Determination 2010/058

Refusal to issue a code compliance certificate for additions and alterations to a house at 26 Resolution Rise, Cooks Beach

Figure 1: The house and alterations

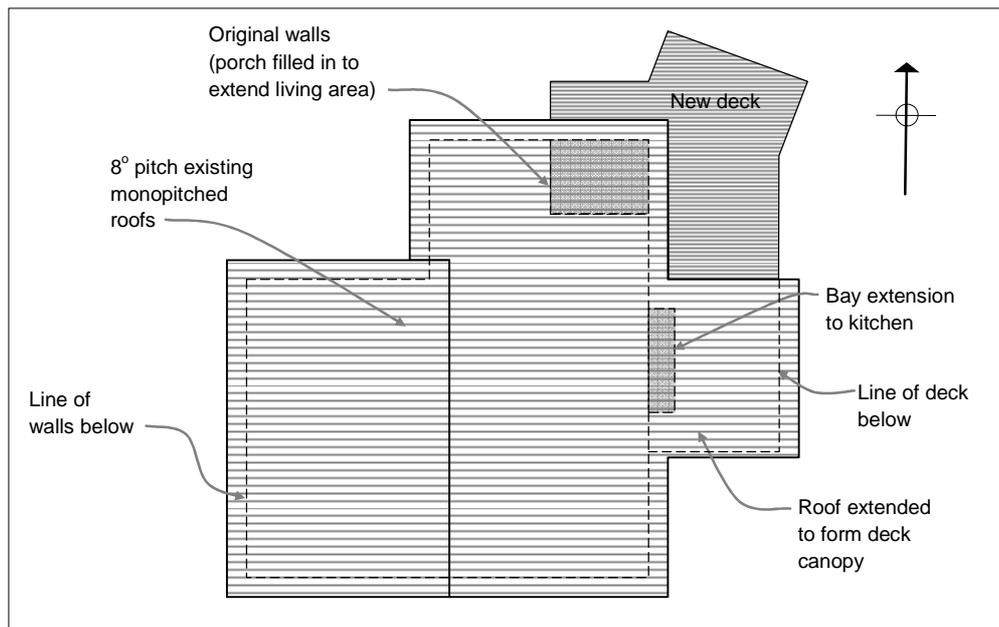
- 7.3 The following changes have been made from the building consent drawings:
- the floor joists to the north east corner were installed over the original porch concrete on 15mm packers, in lieu of pile foundations

- the deck balustrades were changed from open timber to weatherboard-clad balustrades under the deck canopy, with timber benches elsewhere
 - an additional post and beam have been added to the deck canopy.

- 9.1 The authority should, in cooperation with the owners, amend the building consent documents to show what has been built. Once this matter has been resolved to its satisfaction, the authority shall issue a code compliance certificate.
